**N1996A-01A**

## Agilent CSA Spectrum Analyzer, N1996A

### Residual Responses due to Shield Problem on A4 Digital IF Assembly

Figure 3. Check that there is no gap longer than 4mm between shield wall and pc board footprint. Note that some pc boards will have a series of small (~2 mm), regularly-spaced gaps in the solder fillet. This is normal.

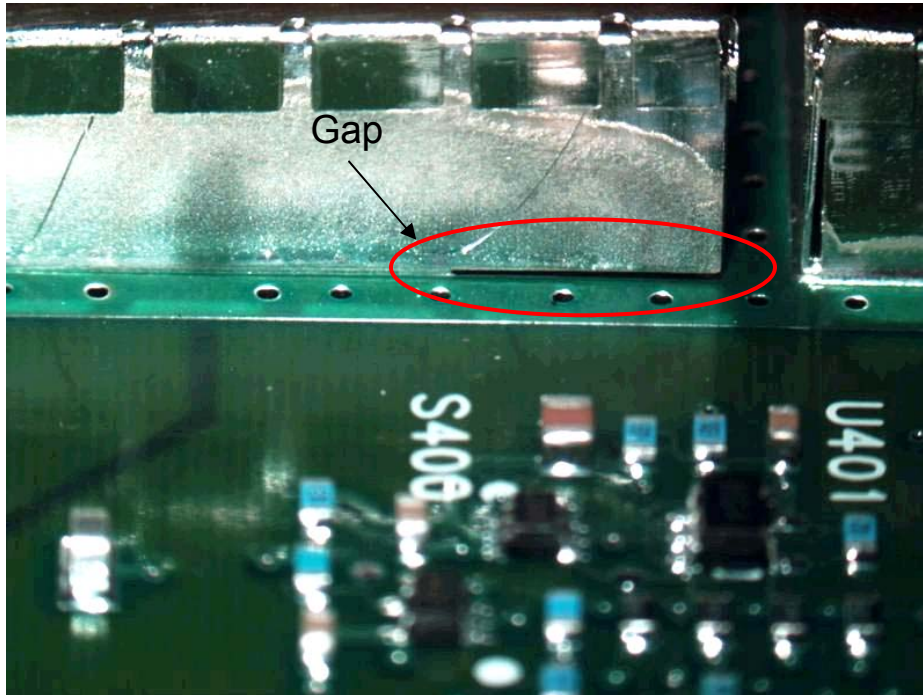
- a. Ideally, there should be a continuous fillet of solder along the outside and inside edges where the shield frame walls meet the pc board. On some pc boards, there will be a series of small gaps (approximately 2 mm) in the solder fillet. This is OK. If there is any gap in the solder fillet greater than 4 mm, re-solder to fill the gap. Refer to Figures 3 and 6. When soldering the edges of the shield walls, be careful not to accidentally touch any pc board components with the soldering iron.

Figure 4. Ensure no excess solder wicked across the top of the shield walls. Uneven surface will prevent lid fingers to reside flat on the shields.

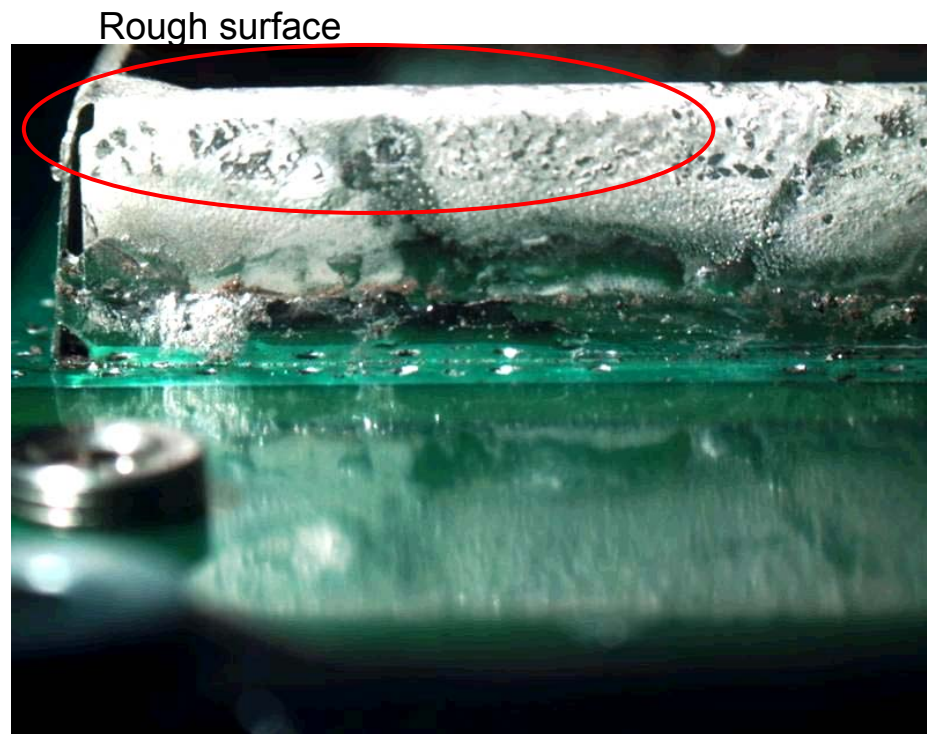
- b. Check that excess solder has not wicked up the side of the shield walls. Refer to Figure 4. The uneven surface created does not allow the shield covers to make good contact.

Figure 5. All shields must align properly to the pc board footprints. No bent or misaligned shields are allowed.

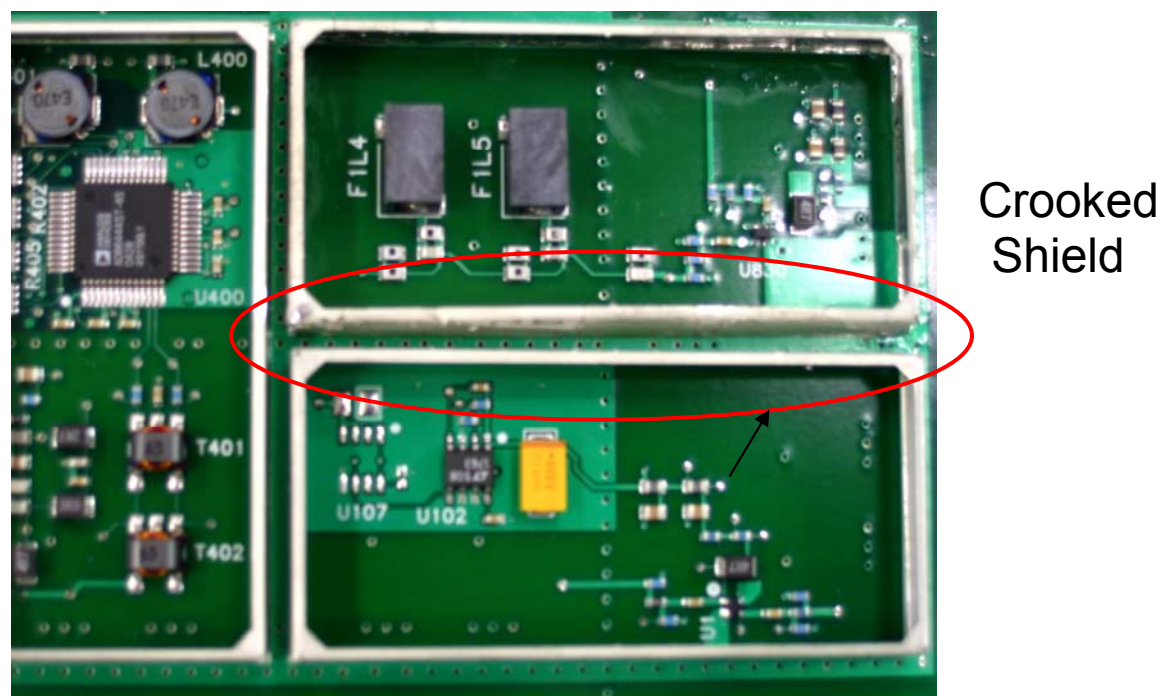
- c. Check that the shield frame walls align properly with the pc board footprint. Refer to Figure 5. If possible, re-solder the shield frame walls so that they are properly aligned. If this is not possible, replace the A4 DIF board with a new assembly.
